REFERENCE:	TSB: 23-097-23 GROUP: 23 - Body	Date:	September 16, 2023	REVISION:	-
VEHICLES AFFECTED:	2023 (WS) Grand Wagoneer/Wagoneer This bulletin applies to vehicles built on or after January 24, 2023 (MDH 0124XX) and on or before February 01, 2023 (MDH 0201XX).			MARKET APPLICABILITY:	
				<input type="checkbox"/> NA	<input type="checkbox"/> CH
				<input type="checkbox"/> EE	<input type="checkbox"/> IAP
				<input type="checkbox"/> SA	<input checked="" type="checkbox"/> MEA
CUSTOMER SYMPTOM:	Incorrect gray stitching on steering wheel (correct stitching on steering wheel should be brown as found on the air bag) Fig. 1 .				
CAUSE:	Incorrect gray stitching on steering wheel.

Fig. 1
Incorrect And Correct Steering Wheel Stitching

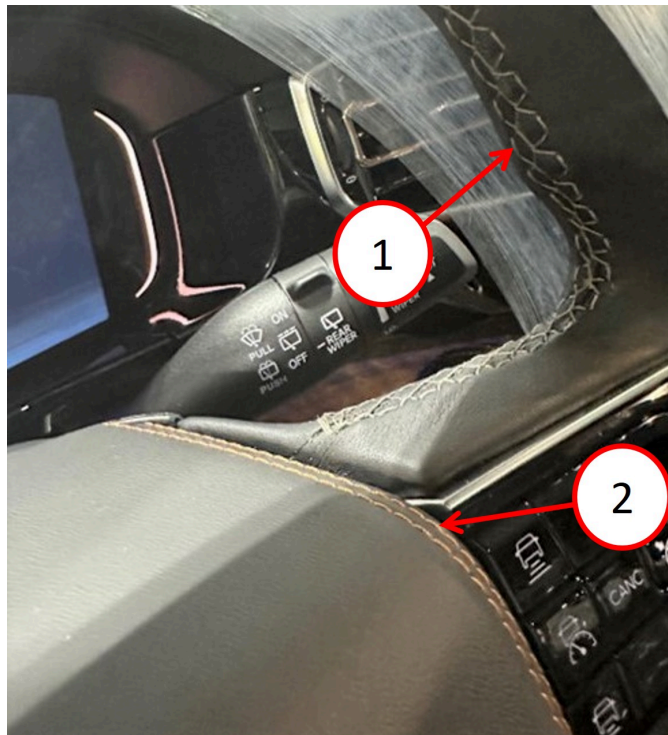
1 - Incorrect Gray Steering Wheel Stitching
2 - Correct Brown Steering Wheel Stitching Found On Air Bag

This bulletin involves replacing the steering wheel.

Qty	Part No.	Description	Notes
1	7HU88XU5AA	Wheel, Steering	Brown Stitching
1	06511578AA	Washer, Hex Lock - 16 x 1.50	Steering Wheel Nut One Time Use

1. Replace the steering wheel. Refer to the detailed service procedures available in DealerCONNECT/ Service Library under: Service Info>19 - Steering / Column / Wheel, Steering / Removal and Installation.
